# Access Compliance Report

## Public Rights-of-Way

### (Curb Ramps)

Intersection ID: 48949	Main Street: OLD_STONE_CROSSING_DR	Cross Street: DAVID_JENNINGS_AV	Location: NW
ADA ID: 291B0DB3BCED	Ramp Type: Combination1	Initial Pass/Fail: Fail	Overall Compliance: No
			Severity Score: 46.25

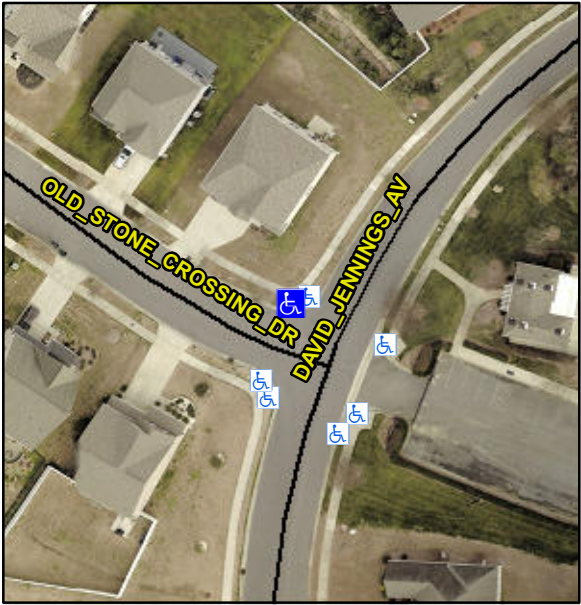
Codes/Mitigation Info/Possible Solution			Field Measurements/Component Compliance		
	Possible Solutions:		<b>Compliance</b>	<b>Description</b>	<b>Data</b>
	<b>Remove &amp; Replace Entire Ramp.</b>		<b>N/A</b>	Ramp Length LT (in)	<b>3.5</b>
			<b>Yes</b>	Ramp Width LT (in)	<b>60.0</b>
			<b>No</b>	Ramp Slope LT (%)	<b>14.4</b>
			<b>No</b>	Ramp XSlope LT (%)	<b>2.3</b>
			<b>N/A</b>	Ramp Length (in)	<b>70.0</b>
			<b>No</b>	Ramp Width (in)	<b>47.0</b>
			<b>N/A</b>	Flare Type LT	<b>N/A</b>
			<b>N/A</b>	Flare Slope LT (%)	<b>N/A</b>
			<b>N/A</b>	Flare Traversable LT?	<b>N/A</b>
<p>Surveyor Notes:</p> <p><b>N/A</b></p> <p>PROW/ADA:</p> <p><b>Not Found, R304.5.1, R304.5.3, R304.3.2</b></p>			<b>N/A</b>	Ramp Slope RT (%)	<b>9.6</b>
			<b>Yes</b>	Ramp XSlope RT (%)	<b>0.6</b>
			<b>Yes</b>	Ramp Slope (%)	<b>1.4</b>
			<b>No</b>	Ramp XSlope (%)	<b>5.5</b>
			<b>N/A</b>	Flare Type RT	<b>N/A</b>
			<b>N/A</b>	Flare Slope RT (%)	<b>N/A</b>

<b>N/A</b>	Flare Traversable RT?	<b>N/A</b>
			<b>N/A</b>	DWS Provided?	<b>N/A</b>
			<b>N/A</b>	DWS Contrast?	<b>N/A</b>
			<b>N/A</b>	DWS Length (in)	<b>N/A</b>
<p>Total Cost:</p> <p><b>\$ 1800.00</b></p>			<b>N/A</b>	DWS Full Width?	<b>N/A</b>
			<b>N/A</b>	DWS Offset (in)	<b>N/A</b>
			<b>N/A</b>	Gutter Slope (%)	<b>N/A</b>
			<b>N/A</b>	Gutter X Slope (%)	<b>N/A</b>
			<b>N/A</b>	Painted X Walk1?	<b>N/A</b>
			<b>To S</b>	X Walk 2 Direction	<b>N/A</b>
			<b>N/A</b>	X Walk 2 Width (in)	<b>N/A</b>
			<b>1.4</b>	X Walk 2 Slope (%)	<b>N/A</b>
			<b>3.5</b>	X Walk 2 X Slope (%)	<b>N/A</b>
			<b>N/A</b>	Ramp inside XWalk2?	<b>N/A</b>
			<b>N/A</b>	Clear Space?	<b>N/A</b>
			<b>N/A</b>	Clear Space to XWalk (in)	<b>N/A</b>
			<b>N/A</b>	Any Obstruction?	<b>N/A</b>
				Obstruction Type	<b>N/A</b>
			<b>N/A</b>	Storm Grate/Utility Hazard?	<b>N/A</b>
				Storm Grate/Utility Type	<b>N/A</b>
			<b>Yes</b>	Surface Condition? (G/P)	<b>Good</b>

Curb Slope (%)	<b>21.0</b>
